DEPARTMENT OF THE ARMY
US ARMY INSTALLATION MANAGEMENT COMMAND
2405 GUN SHED ROAD
JOINT BASE FORT SAM HOUSTON, TX 78234-1223

Reference your letter, October 29, 2015, subject: Second Request for Additional Information – Technical Review of the U.S. Army's Application to Amend the Source Materials License for Depleted Uranium from Davy Crockett M101 Munitions - (SUC-1593, Docket No. 40-09083).

Army Responses to NRC's Second RAI, License # SUC-1593 Amendment Application

General License for three sites located at Fort Carson, Colorado

Fort Knox KY

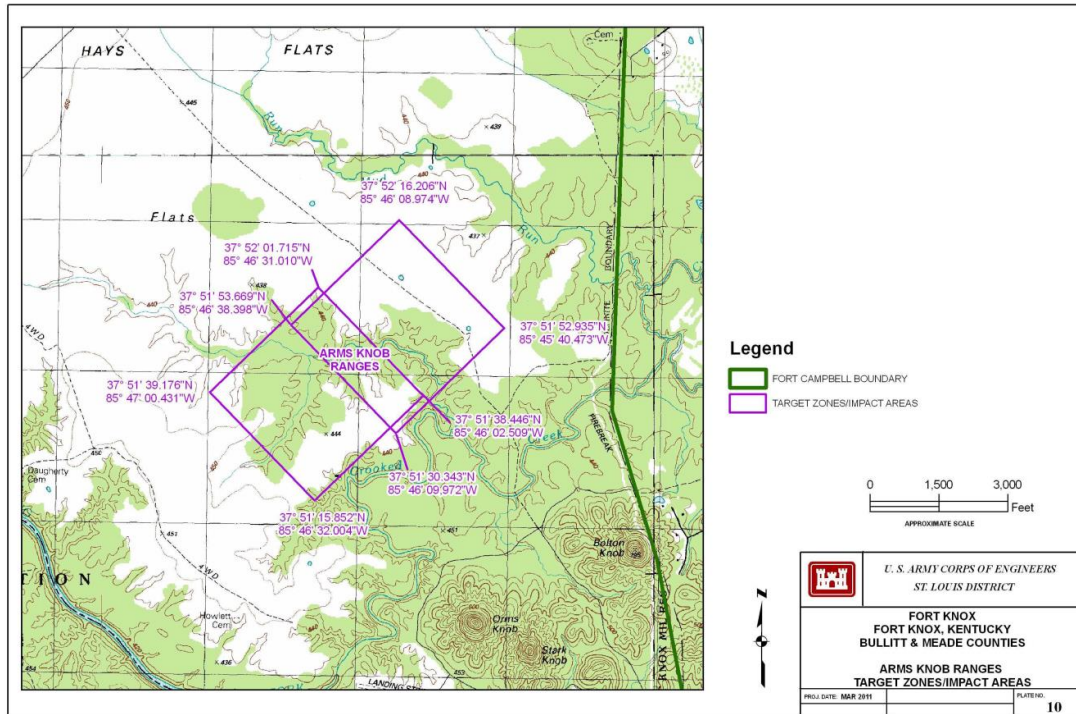
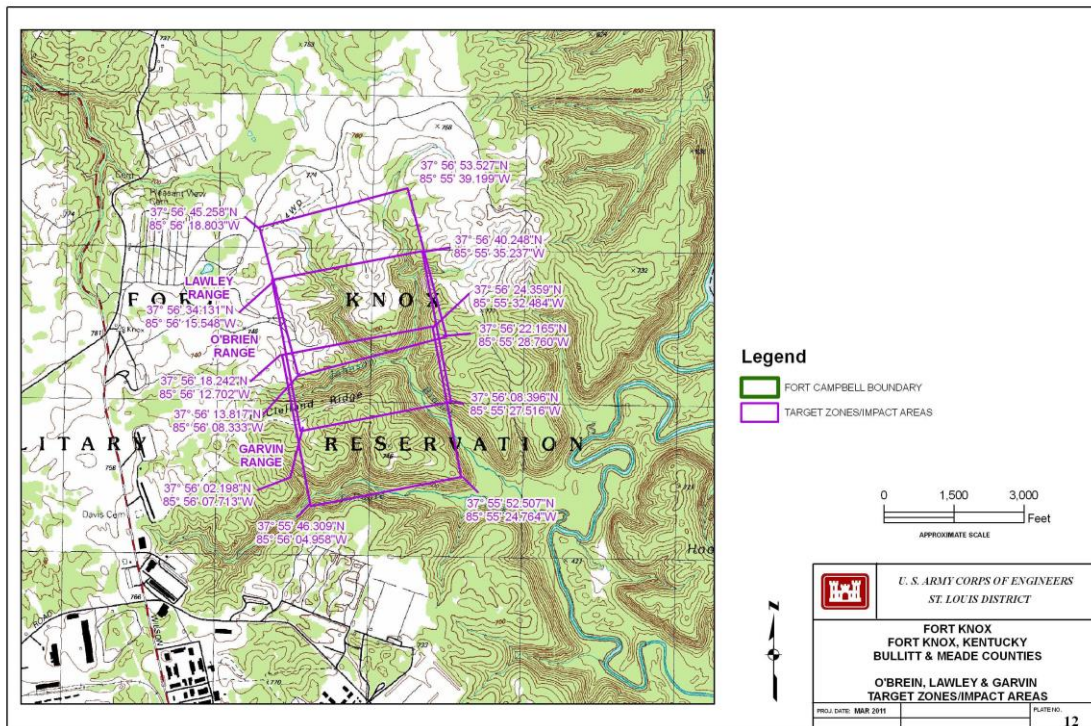
The legend should read "FORT KNOX BOUNDARY"

M101 firing was on the O'Brien (aka O'Brein) Range.
The legend should read "FORT KNOX BOUNDARY."

Joint Base Lewis-McChord/Yakima Training Center WA

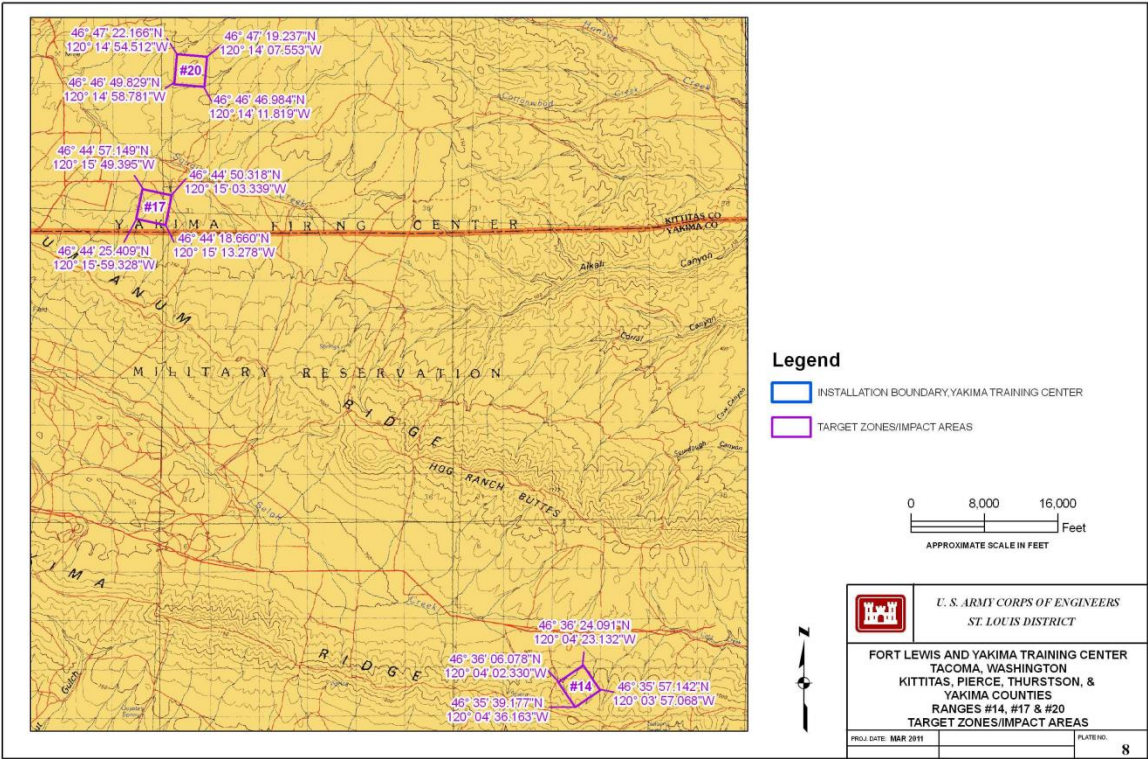
Range 53 is not an M101 impact area; range 52, OP8 and OP9 are M101 impact areas
